Item ID: D212-664-201TRN

Item Name: Crosstube Turning Detail

DART AEROSPACE LTD	Work Order:	99238
Description: Crosstube Assembly (205/212 High Aft)	Part Number:	D212-664-241
Inspection Dwg: D212-664-241 Rev: D		Page 1 of 2

DRAWING NO. D212-664-241	TITLE CROSSTUBE ASSY (205/212 HI AFT)	REV. D	DART AEROSPACE LTD ENGINEERING ORDER		D.E.O. NO. D212-664-241-D-1	SHEET NO. SHEET 1 OF 2	SCALE NTS
DRAWN	CHECKED	MFG. APPR.	APPROVED	DE APPR.			
DATE 11.04.07	DATE 11.04.11	DATE 11.04.12	DATE 11/04/12	DATE 11.04.12

**D212-664-241/-241B
ASSEMBLY DETAIL**

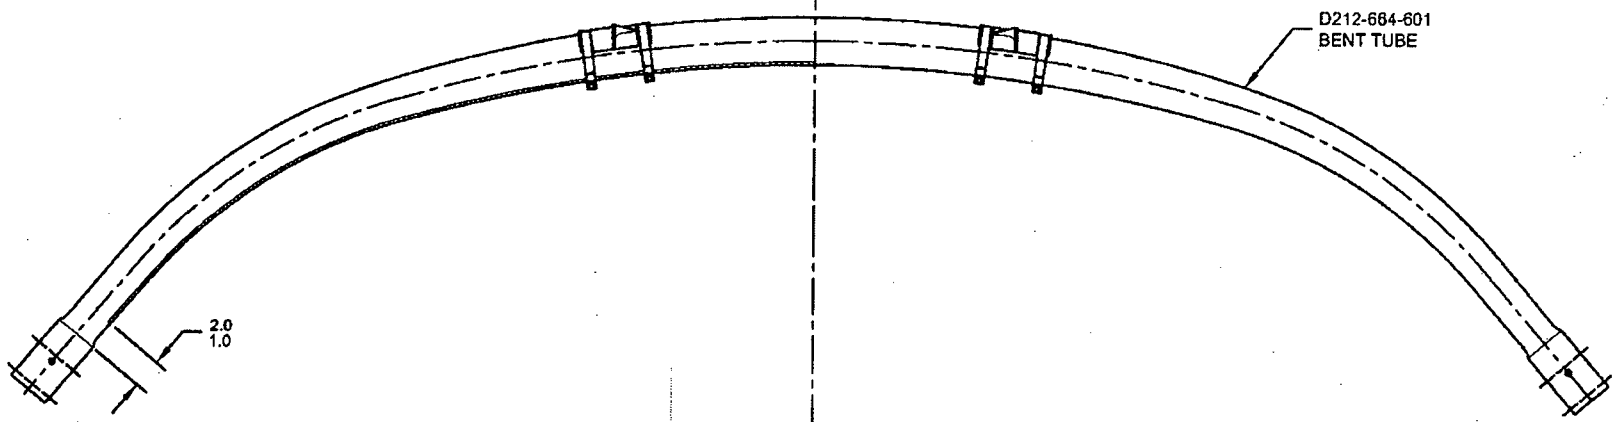
PURPOSE:

ADD AN INSPECTION WINDOW TO UNDERSIDE OF CROSSTUBE.

IS:

WAS:

MASK AREA PRIOR TO PAINTING,
REMOVE MASKING AFTER PAINT
AND APPLY CLEAR COAT
